Product Change Notification

Change Notification #: 112655 - 00
Change Title: Intel® Desktop Board DH61BE, Boxed and Bulk
PCN 112655-00, Product Material
Changed USB 3.0 Stepping
Date of Publication: October 10, 2013

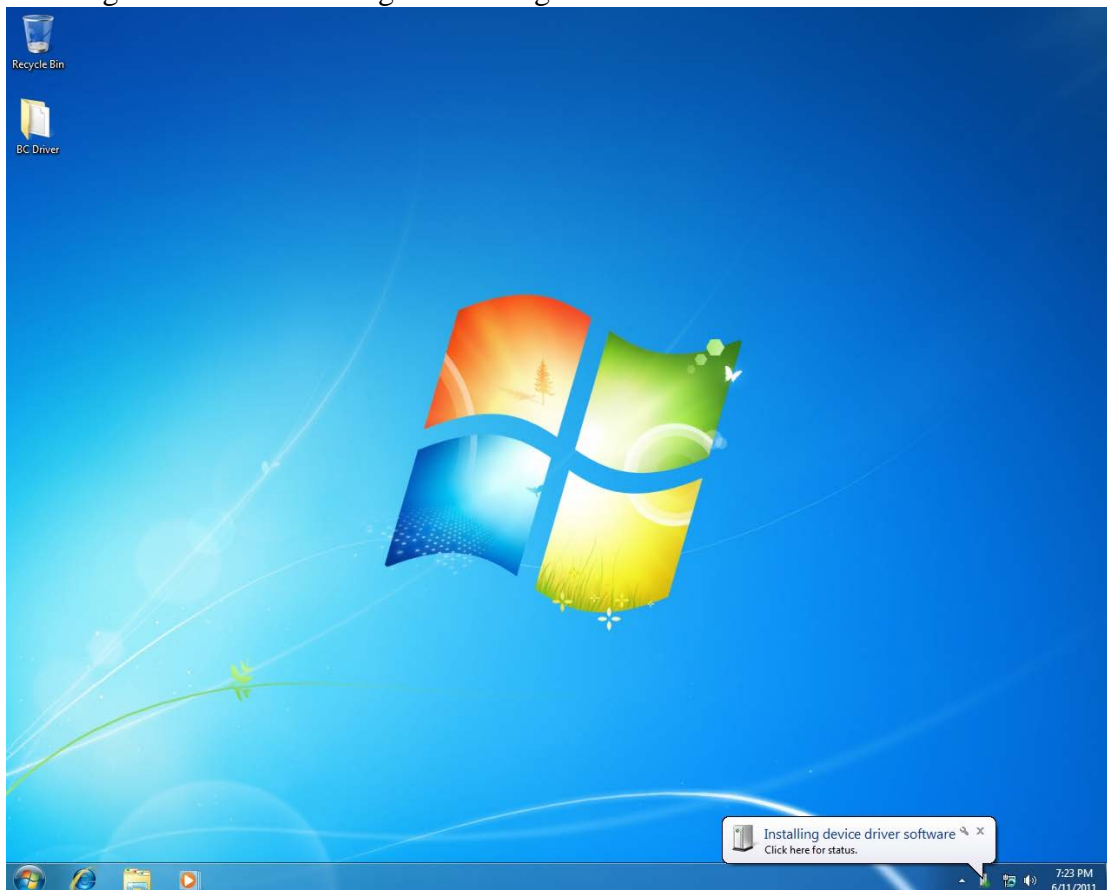
Change USB3.0 controller from A stepping to F1 stepping.

It has been observed that the change for the USB3.0 controller reports a "New device detected" in some operating systems. Microsoft* Windows will display a message and automatically install the necessary drivers; however, customers may wish to update their OS image to avoid the message. See image below:
